SACRAMENTO COMMUNITY CENTER AUTHORITY

MINUTES OF THE MEETING OF THE GOVERNING BOARD  
OF  
SACRAMENTO COMMUNITY CENTER AUTHORITY

That that certain document entitled "Addendum #2", dated June 10, 1971, which is the second addendum to the specifications for the construction of the Sacramento Community Center Complex, 13th and 14th, J and L Streets, Sacramento, California, is hereby approved.

SECTION AT RAIL  
SECTION AT R.A. GRILLE (D)  
CONC. RAIL AND R.A. GRILLE BTWN. ORCHESTRA 129 AND  
ORCHESTRA PIT (SEE PLAN - SHT. A3-2 AND INTERIOR ELEV. - SHTG. A3-31 AND A3-34)  
SCALE 1/2" = 1'-0"

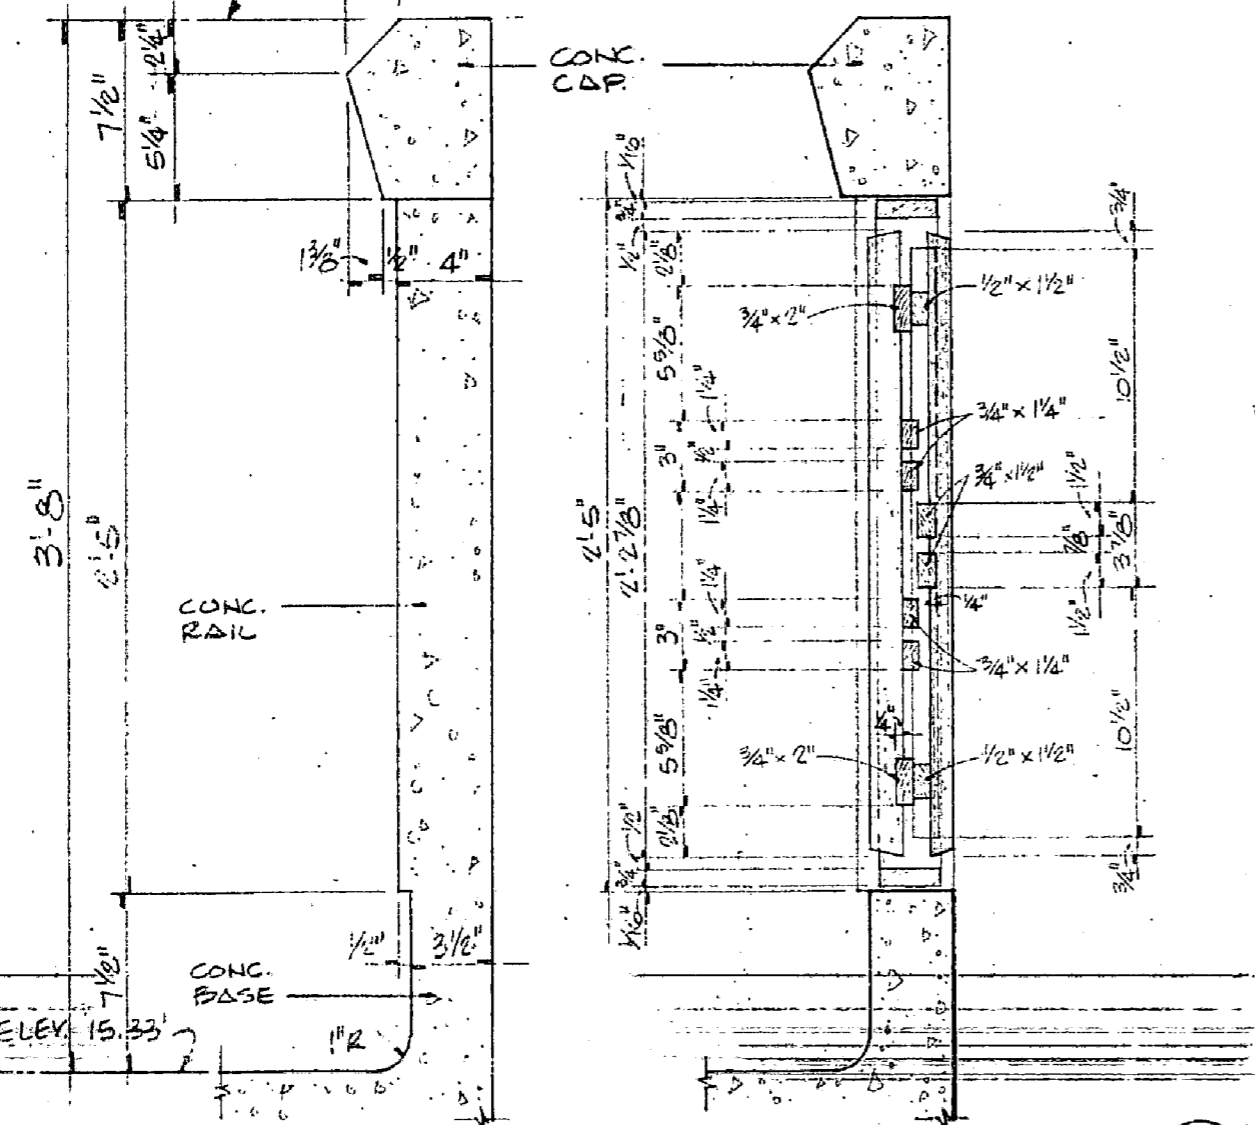
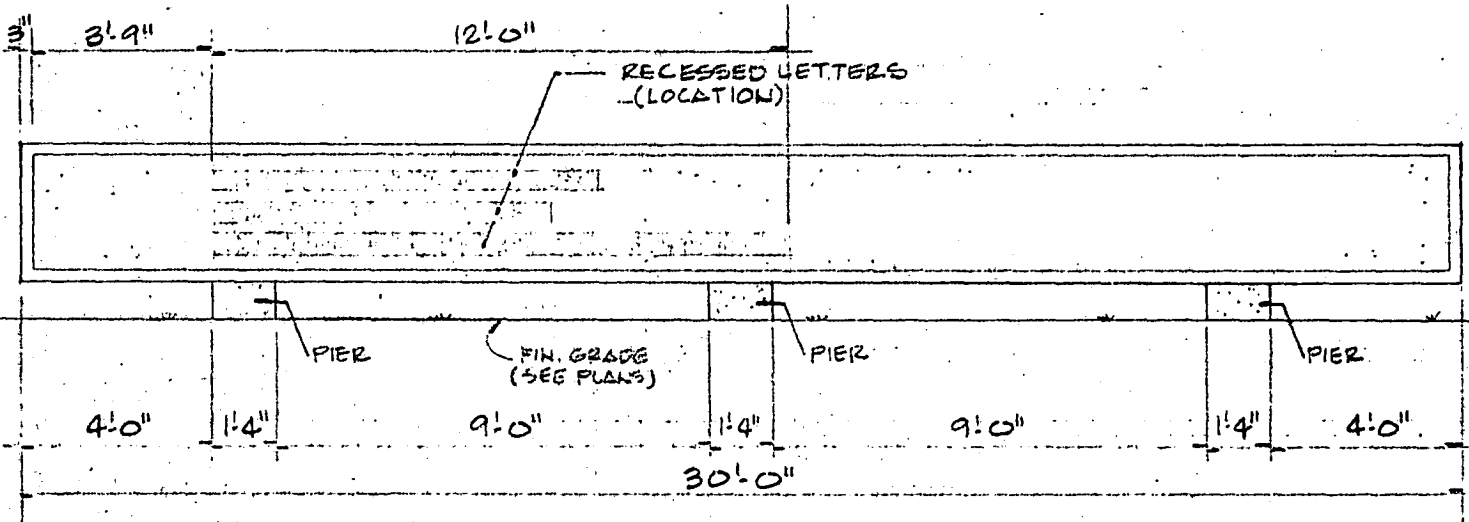
Wood return air grilles shown in concrete rail between Orchestra 129 and Orchestra Pit shall conform to Addenda Drawing No. 29

THIS DRAWING IS TO CLARIFY PROPORTIONS OF CONCRETE SIGN SHOWN IN DRAWINGS - DETAIL 1/AS-7. ALL NOTES, DETAILS, DIMENSIONS, ETC. SHOWN IN DETAIL 1/AS-7 APPLY.

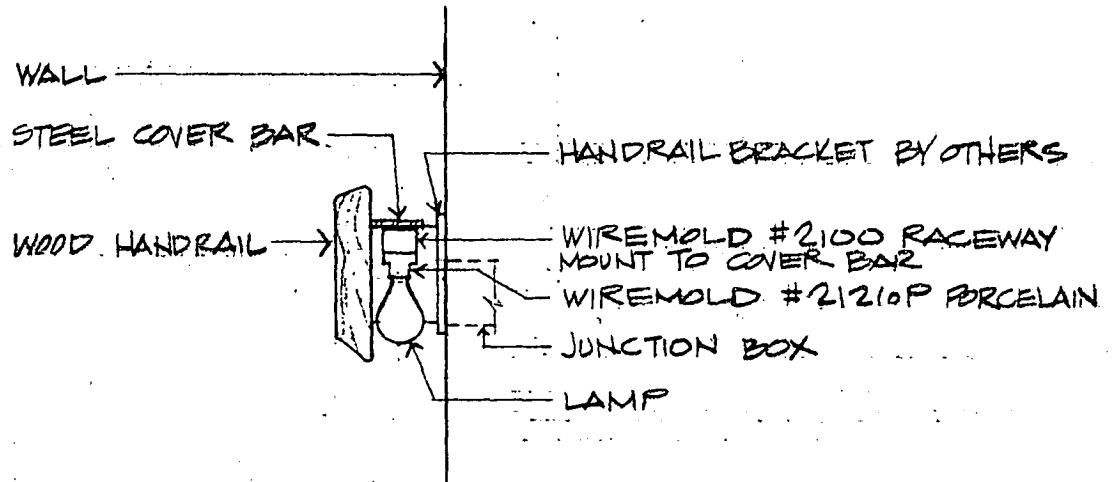
The proportions of concrete sign shown in Detail 1/AS-7 are clarified by Addenda Drawing No. 30

MOUNTING DETAIL - FIXTURE TYPE 'DDD'

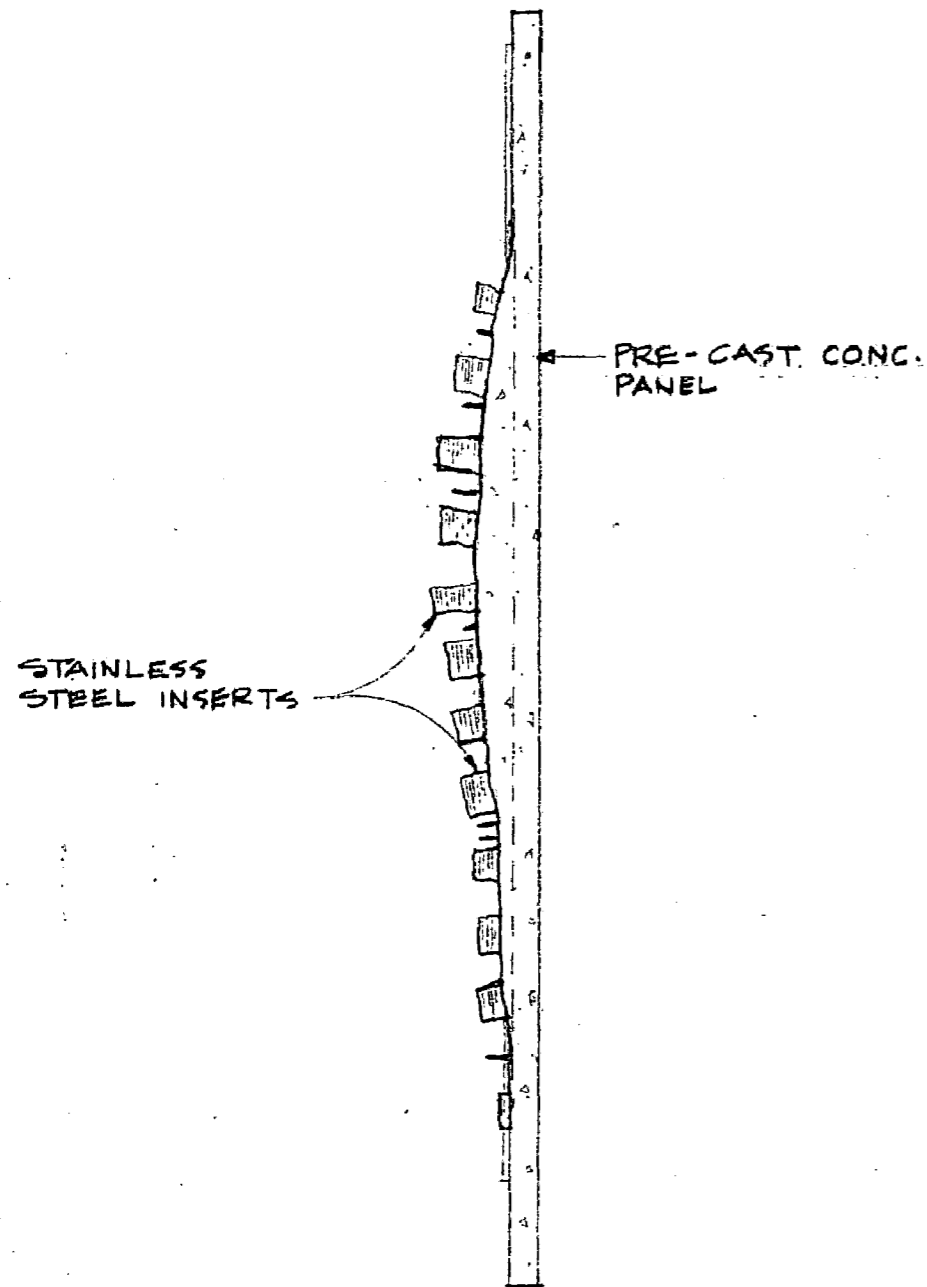
Fixture type 'ZZ4' shall read "wiremold", see addenda drawing #31, 5 type 15A15 lamps, Orchestra area handrails." in lieu of that shown.
